# UNITED STATES PATENT AND TRADEMARK OFFICE

APPLICATION NO.	FILING DATE	FIRST NAMED INVENTOR	ATTORNEY DOCKET NO.	CONFIRMATION NO.
09/779,478	02/09/2001	Toru Yamaguchi	018842.1162	9443
24735	7590	04/09/2004		
BAKER BOTTS LLP C/O INTELLECTUAL PROPERTY DEPARTMENT THE WARNER, SUITE 1300 1299 PENNSYLVANIA AVE, NW WASHINGTON, DC 20004-2400			EXAMINER LEO, LEONARD R	
			ART UNIT 3753	PAPER NUMBER

**Office Action Summary**

## **DETAILED ACTION**

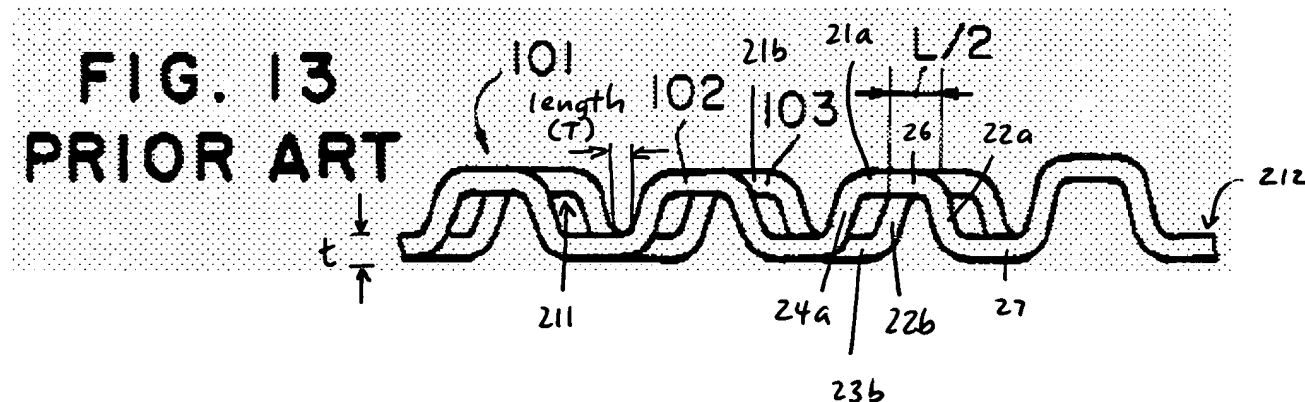
With respect to Tomoko (JP 7-280484), applicants state the “connection length is  $L/2$ .” However, the ***connection length*** is not the same as ***the length (T) of the connecting portion***. Again, applicants are determining the connecting portion length (T) of Tomoko based on critical points inconsistent with applicants’ claims and specification. Thus, it is not clearly understood why applicants are using a different standard when comparing Tomoko with the instant invention. Applicants’ amendment to the specification and Figures 5-6 disclose the length (T) in terms of critical points along the inner surface 211. There is nothing in the originally filed specification of defining the length (T) in terms of the outer surface of the connecting portion.

As shown below, the length (T) is determined according to applicants' definition in the specification. Reference numerals similar to applicants' Figure 5 are employed for ease of understanding. Thus, the length (T) of the connecting portion of Tomoko is less than plate thickness (t). As evidenced by Gerstung below, the prior art method of forming the offset louvered fin is known to produce a length (T) of both an outer surface and an inner surface of the connecting portions less than or equal to the fin thickness.

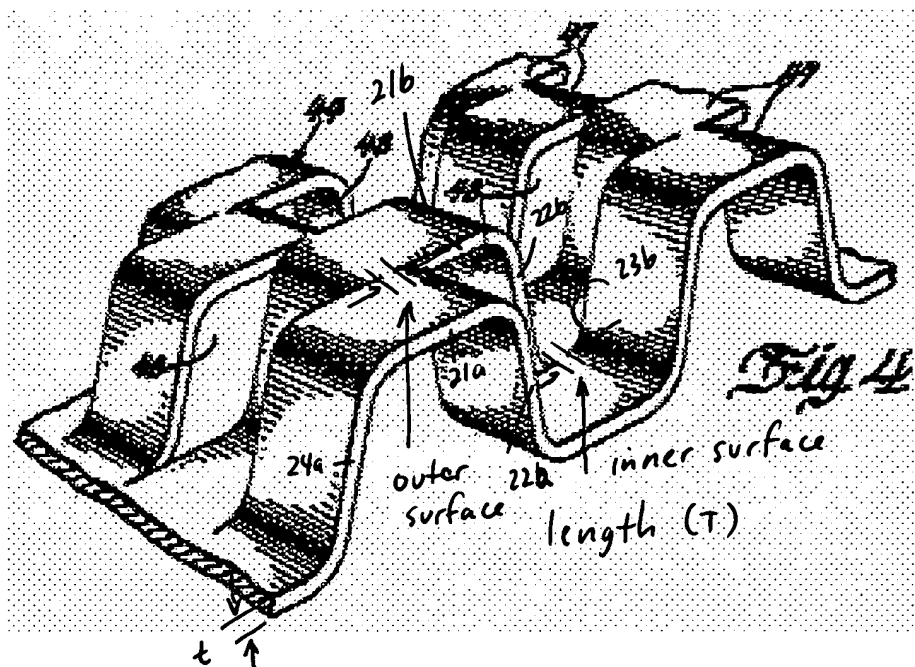
With respect to Figure 4 of Gerstung et al, the Examiner does not fully understand applicants' argument. As best understood, applicants' statement, "the overlapping areas of Gerstung's crests are not separated from the adjoining element of each of Gerstung's plates" is exactly the same structure as applicants' connecting portions. The structure of where the "crests are not separated" is where the adjoining elements 47 are uncut and not severed as shown in red on the following page. Reference numerals similar to applicants' Figure 5 are employed for ease of understanding. Thus, the length (T) of the connecting portion of Gerstung is less than plate thickness (t). ). As stated above, Gerstung discloses a length (T) of both an outer surface and an inner surface of the connecting portions less than or equal to the fin thickness.

In summary, the originally filed specification does not disclose a length (T) of each connecting portion defined in terms of **both** the outer surface and inner surface being less than or equal to the fin thickness. Only the inner surface is disclosed to define the length (T).

According to applicants' definition of the length (T) of the connecting portion, both Tomoko and Gerstung meet the claimed invention, such that the length (T) of both the outer surface and inner surface are less than or equal to the fin thickness.
